Response to Comments for the Federal Register Notice for the Texas and Oklahoma Regional Haze State Implementation Plans; Interstate Visibility Transport State Implementation Plan to Address Pollution Affecting Visibility and Regional Haze; and Federal Implementation Plan for Regional Haze

Docket No. EPA-R06-OAR-2014-0754

12/9/2015

GUMO Glide Path with Alternative Natural Conditions
(Luminant (0061) Figure 2 and AECOM (0061/0075) Figure 3-6)

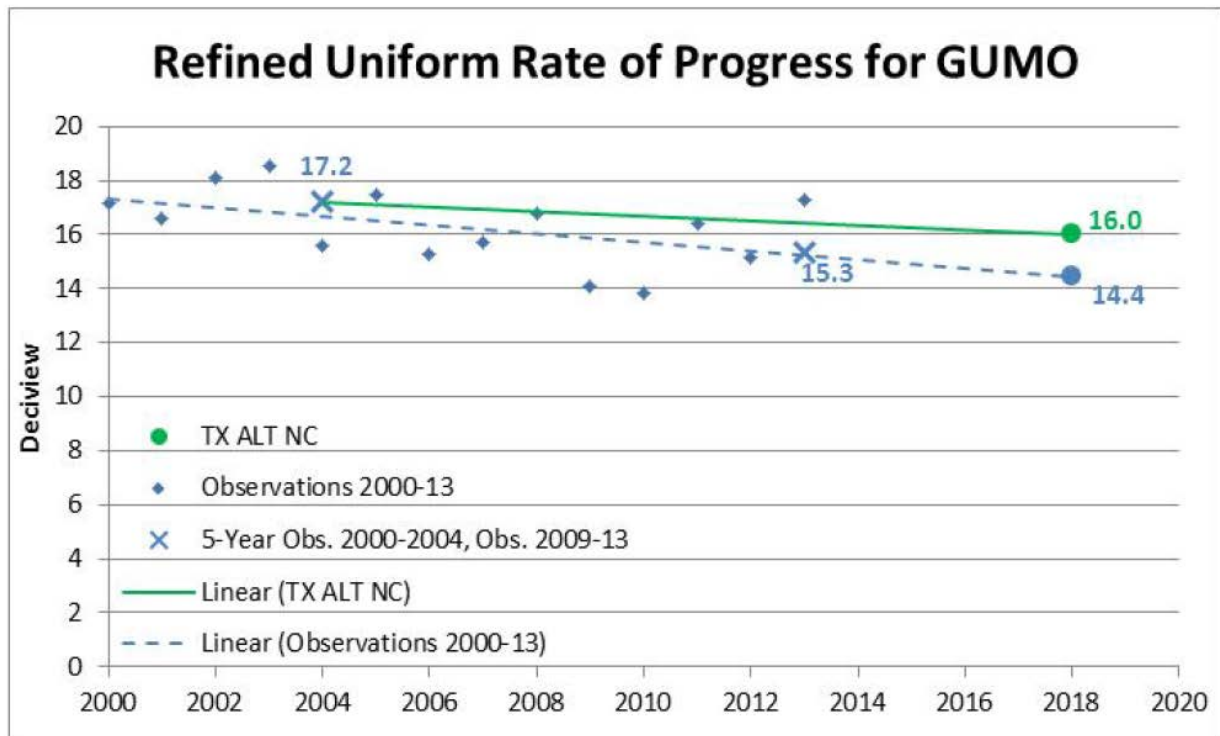
and Figures 3-6 and 3-7 from AECOM 0061/0075) show the resulting uniform glide paths for the two Class I areas using the TX ALT NC results for natural conditions. (Figure 4 from Luminant 0061 and Figures 3-8 from AECOM 0061/0075) is an alternate figure shown for BIBE without the anomalous 2011 information included in the regression line. With the TX ALT NC values, the new URPs for 2018 become 16.01 dv for GUMO and 15.42 dv for BIBE. Using these adjusted natural condition end points and the associated glide paths, it is apparent that the 2018 URP goals will be met for GUMO based on the current IMPROVE measurements' linear regression. BIBE will also meet the revised glide path, and this does not factor in uncontrollable international emissions from Mexico (more discussion on this issue is provided below). Thus, the weight of evidence indicates that with appropriate adjustments and based on the current visibility data, the 2018 URPs will be met for all three Class I areas under consideration in EPA's proposed rule.

FIGURE 10: BACK TRAJECTORIES ON THE 20% WORST DAYS FOR BIG BEND, 2011-2013

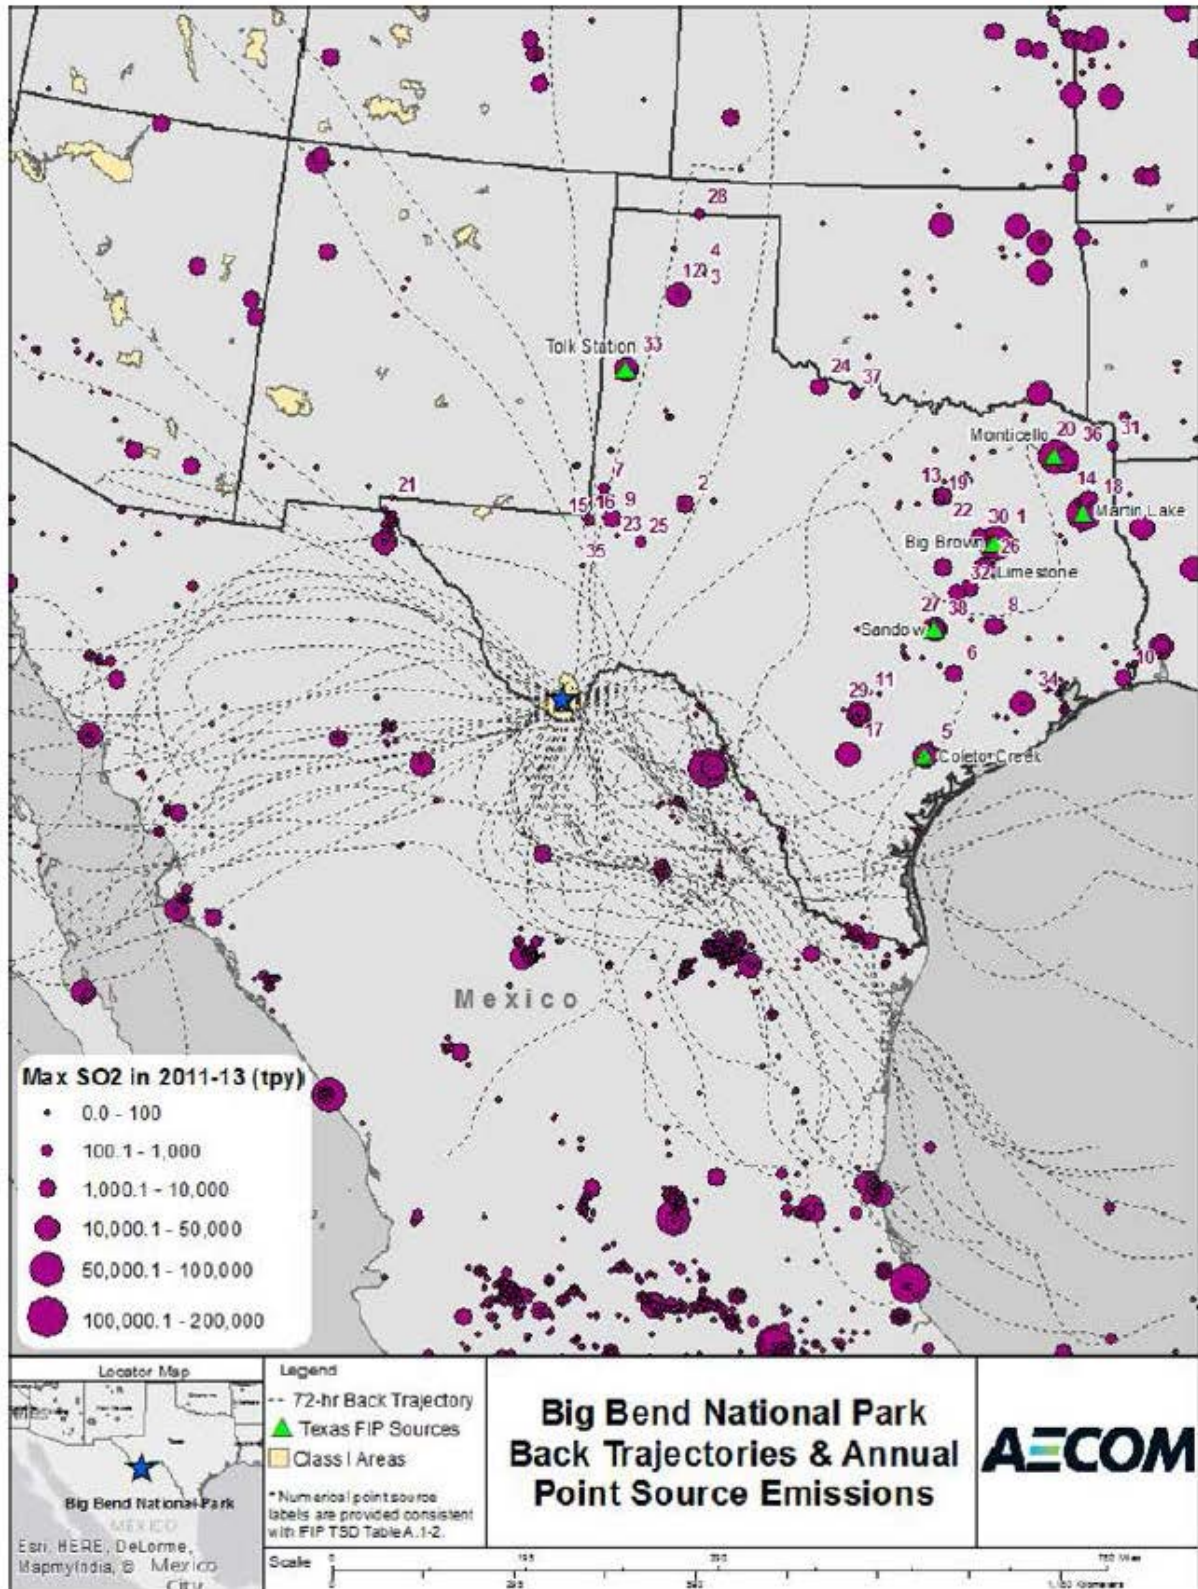
AECOM Figure 4-2 shows the back trajectories at BIBE from 2011-2013 on the 20% worst days. The 38 facilities in Texas that were modeled by EPA are labeled in the map. The back trajectories illustrate that BIBE most often experienced air from the west, south, and southeast transport regimes. The most recent facility-aggregated point source SO₂ emissions for Texas and

In contrast, trajectories indicate that emissions from Mexico, particularly the facilities such as Carbon I and Carbon II on the Texas/Mexico border, heavily influenced BIBE haze conditions. These point sources stand out as large emitters just southeast of BIBE and only 230 km away. Trajectories from the west and south further indicate the transport of natural dust events from the Chihuahuan Desert and/or fire activity. For example, as shown in AECOM Figure 4-3 in comment 0061/0075, one of the top five worst haze days (April 21, 2011) indicated southerly to southwesterly transport which brought in smoke from wildfires. As noted previously, TCEQ has identified numerous dust and fire events, particularly in 2011, that adversely influenced particulate matter measurements. Furthermore, a recent long-term dust event climatology identified 16 local dust events during 2000-2007 that specifically affected BIBE.⁸⁰ According to the 2011 NEI (version 1), wildfires in 2011 in Texas alone account for approximately 188,970 tons of PM_{2.5} and 222,985 tons of PM₁₀.⁸¹ These statistics further support the TX ALT NC natural conditions presented above.

FIGURE 11: BACK TRAJECTORIES ON THE 20% WORST DAYS FOR GUADALUPE MOUNTAINS, 2011-2013

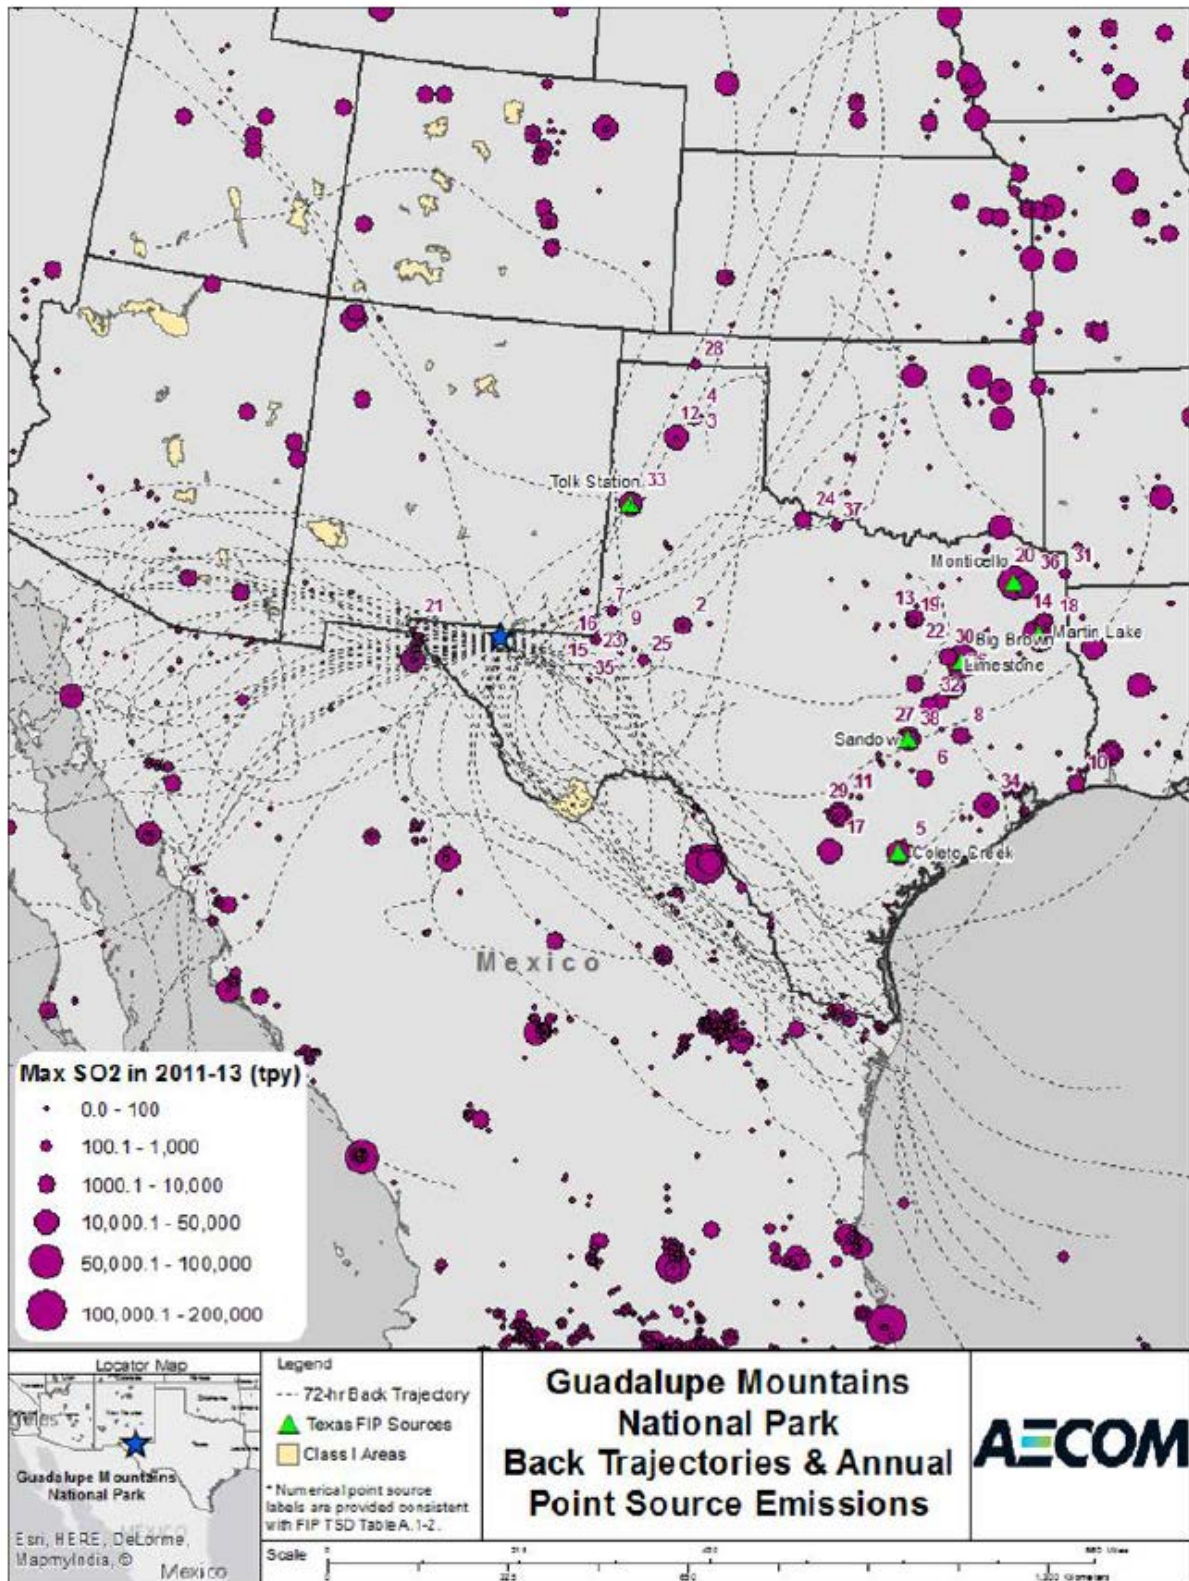
Similar to BIBE, as shown in AECOM Figure 4-5, back trajectories to GUMO on the 20% worst days show that GUMO's haze conditions were influenced by west, south, and southeast transport regimes. GUMO infrequently experienced northeasterly transport from the direction of the facilities targeted in EPA's proposed FIP during the 20% worst haze days where 21 out of 66 (approximately 32%) trajectories originated from the Texas FIP sources. The farthest distance a trajectory must travel to reach a Texas facility with a proposed new emission limit is approximately 960 km away from GUMO. Like the approach taken with BIBE, the trajectory uncertainty of 22.5% was used. Thus, 22.5% of 960 km is about 216 km. With this procedure, we find that only 8 trajectories (about 12%) originated from within 182 km of Coletto Creek (22.5% of 800 km), and we find that only 5 trajectories (about 8%) originated from within 216 km of a Luminant facility.

Figure 1. Uniform Rate of Progress and 2018 Projected Progress at the Guadalupe Mountains.⁶

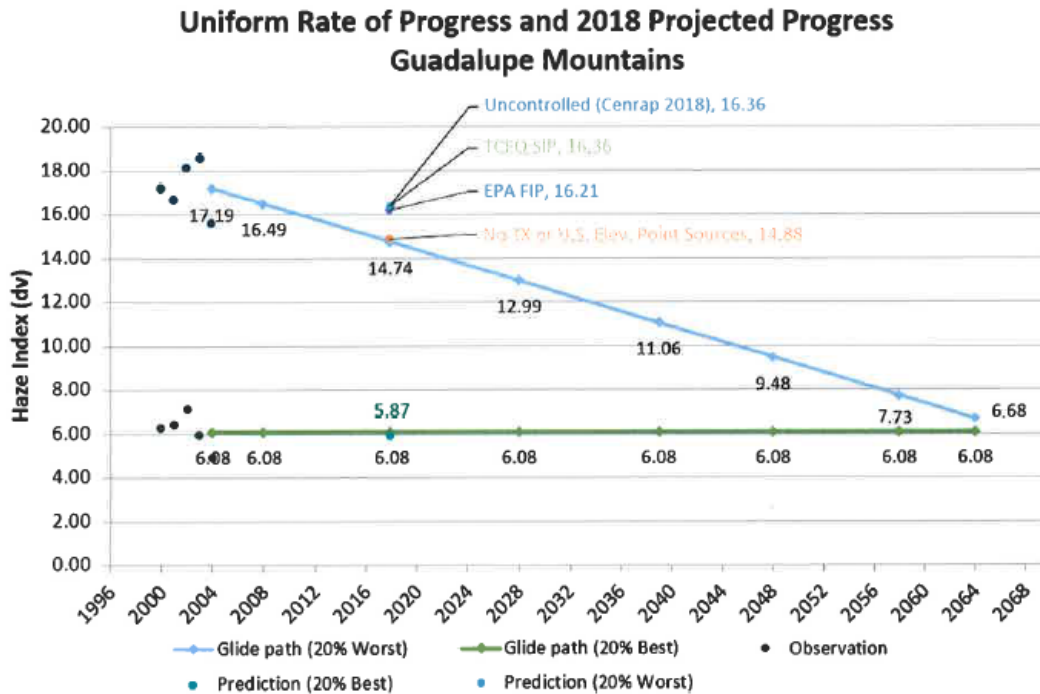
Figure 1 provided by Xcel Energy in comment 0064 (reproduced below) shows the glide path for the Guadalupe Mountains, the most impacted Class I area for the Tolk Generating Station. The uncontrolled haze index value of 16.36 dv is the modeled value determined in the 2018 baseline scenario processed by ENVIRON for EPA. TCEQ did not propose additional reasonable progress controls in its SIP, citing the growth and control projections already incorporated into the 2018 baseline emissions data; therefore, the TCEQ SIP value is equivalent to the uncontrolled 2018 baseline scenario value. The EPA FIP value of 16.21 dv corresponds to the modeled haze index obtained from ENVIRON's high control efficiency modeling scenario. The exclusion of all of Texas and other United States elevated point sources resulted in a modeled haze index value of 14.88 dv, meaning that Mexican sources and natural contributions are projected to account for 92%, or all but 1.48 deciviews, of visibility impairment in the Guadalupe Mountains.

**Source Contribution to 2018 Deciview Haze Index at Guadalupe Mountains, W20 Group
(Figure 2 provided by Xcel Energy (comment 0064))**

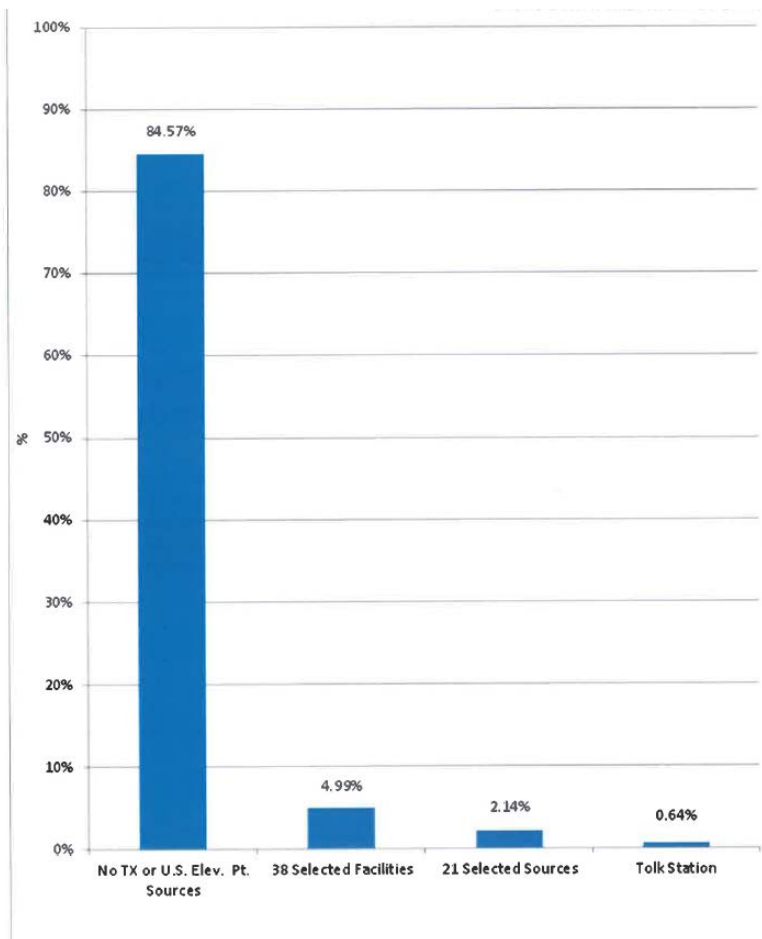
Xcel Energy provided (Xcel Energy Figure 2) which shows the average source contribution to the 2018 deciview haze index at the Guadalupe Mountains. The unaltered 2018 baseline scenario resulted in a haze index of 17.19 dv while the exclusion of Texas and other United States elevated point sources resulted in a value of 15.80 dv. The 38 selected facilities refer to the facilities chosen by EPA for a haze index contribution analysis based on 2009 annual emissions and the distances to the nearest Class I areas (Q/D analysis). The 21 selected sources refer to the emissions sources chosen by EPA to be considered for proposed controls under the FIP and these source collectively contribute only 0.18 dv to the visibility impairment at Guadalupe.

⁶⁶³ We note that Xcel's figure 2 above is not a good representation of the relative visibility impacts because deciviews are a logarithmic function of extinction.

Quarterly and Annual SO₂ Emissions from Luminant Units Proposed by EPA for Further Controls (Table 11 and Figure 9 provided by Luminant (0061))

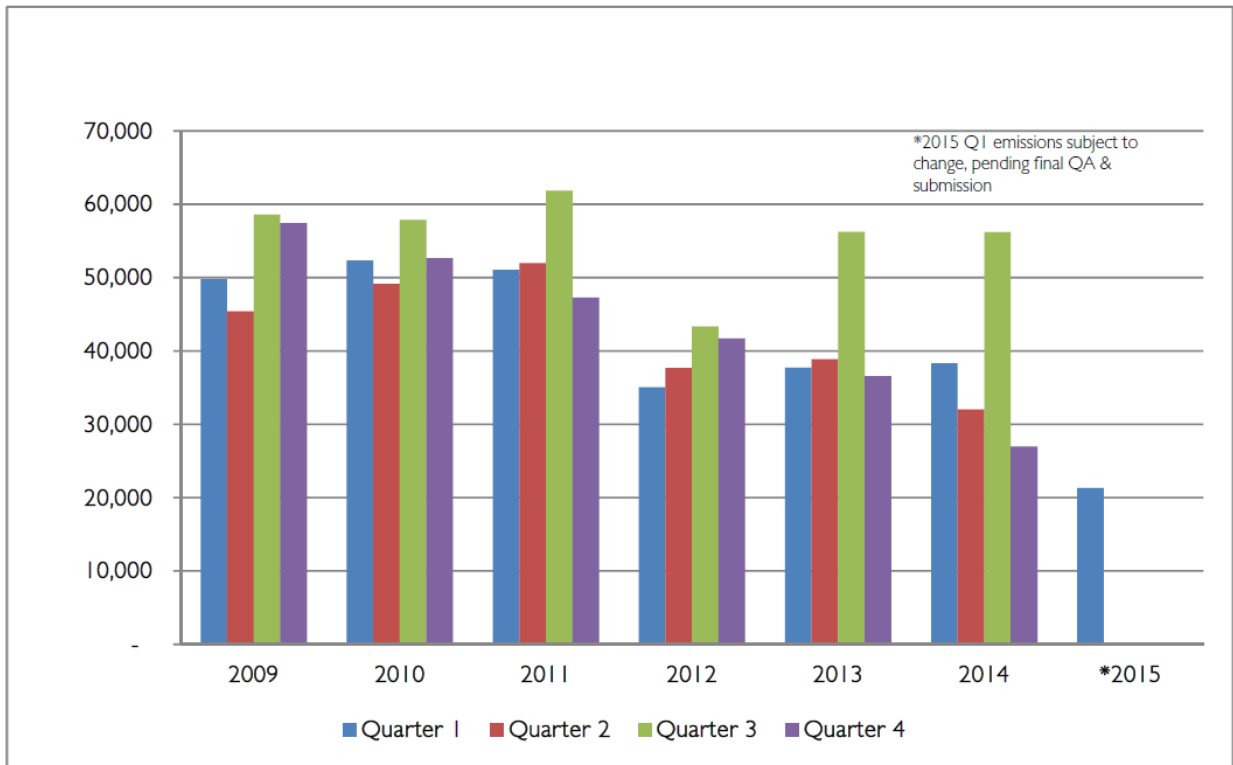
(Table 11 and Figure 9 provided by Luminant (0061)) shows the quarterly and annual SO₂ emissions for these units from 2009 to 2014, as well as the first quarter of 2015.⁶³³

Luminant noted that first quarter 2015 SO₂ emissions are sharply lower—approximately 57% lower than the first quarter of 2009 and about 44% lower than the first quarter of 2014. Again, the data unequivocally show that SO₂ emissions are trending down, and thus there is no basis for EPA’s proposal. These data also underscore the arbitrary nature of EPA’s approach of adjusting ENVIRON’s modeling based on three years of “actual” emissions from 2009 to 2013.⁶³⁴ As explained by Sargent and Lundy in its report prepared in support of Luminant’s comments, EPA’s selective use of data significantly understates the cost-effectiveness (that is, understates the cost per ton of SO₂ removed) and overstates the estimated benefits that EPA relies on for its

We disagree with the commenter that our adjusted actual emissions do not reflect the actual emissions at these units, as shown in Table 11 and Figure 9 of the Luminant comments. We used actual annual emissions taking a three year average of emissions from 2009-2013, excluding the maximum and minimum years. Table 11 and Figure 9 show emissions from this same period and more recent data but break up annual emissions into quarters and combine emissions across all Luminant units with proposed controls. We note that 3rd quarter SO₂ emissions are roughly constant from 2009-2014 and this period is typically when high sulfate impact days are observed. We used the most recent complete data that was available at the time we developed our analysis, 2009-2013, and excluded the max and minimum years to get a reasonable estimate of typical actual emissions. We provide additional information on recent emissions data from these sources in a separate response to comment.

EPA Proposed URP Glide Path for GUMO to 2018 and a Linear Regression Based on IMPROVE Observations (AECOM (0061/0075) Figure 2-7)

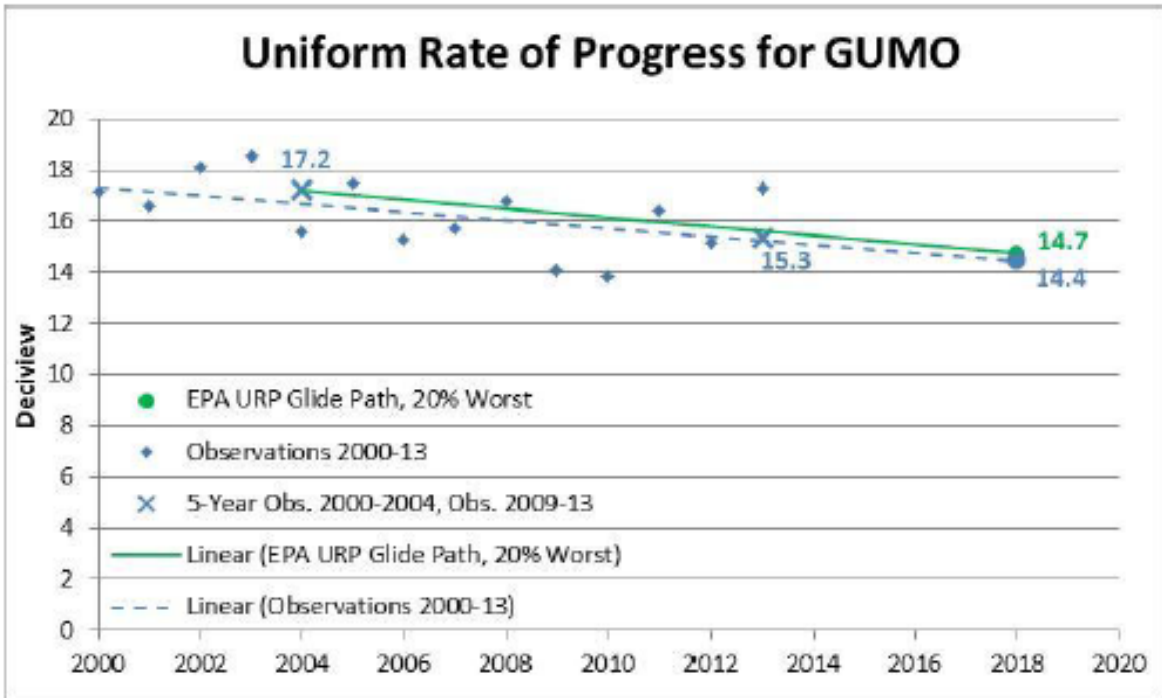
AECOM Figures 2-6 through 2-8 show the same IMPROVE data as compared to EPA’s approved URP for WIMO and its proposed URPs for BIBE and GUMO. With respect to the URP and its associated glide path, WIMO and GUMO indicate they are currently measuring conditions below the uniform glide path (green line). EPA recognizes this progress is greater than anticipated by the CENRAP modeling performed in support of the regional haze SIP.⁴³ BIBE does not indicate it is currently measuring below the uniform glide path; however, BIBE’s default natural conditions do not wholly represent the real impact of natural causes of hazy conditions. Further, given the projected emission trends shown in AECOM Figure 2-2, a linear regression⁴⁴ of the annual IMPROVE observations (dashed blue line) can be used to show the actual and projected rate of improvement for the 20% worst visibility conditions. Projecting this observation-based regression to 2018, the data clearly show that both WIMO and GUMO are on

**Observed and predicted W20% haze index values for Big Bend National Park.
(Figure 2 of Alpine (0078))**

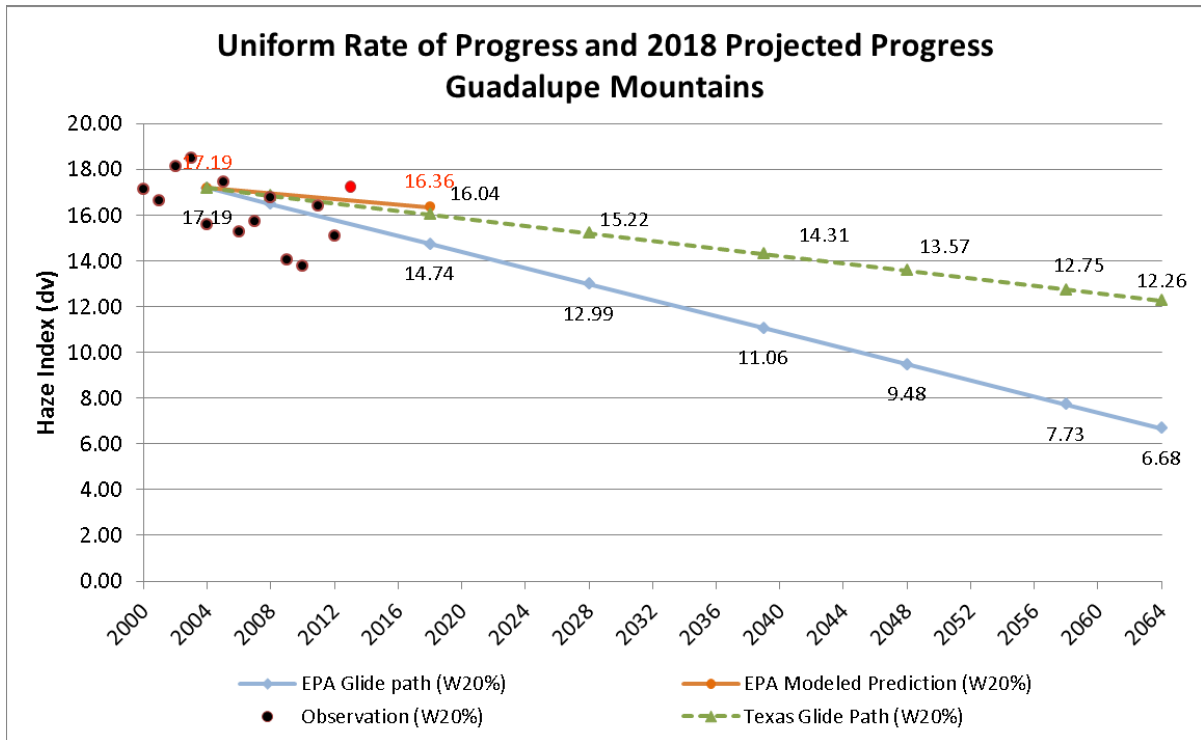
Alpine provided Figures 2 through 4 in Alpine comment 0078, showing these impacted W20% observation calculations are highlighted as red dots in 2011 and 2013.

Shown in Table 1 and Figures 2 through 4 of comment 0078, recent observations (black dots in Figures 1, 2, and 3) from these Class I areas indicate significant progress during the W20% days
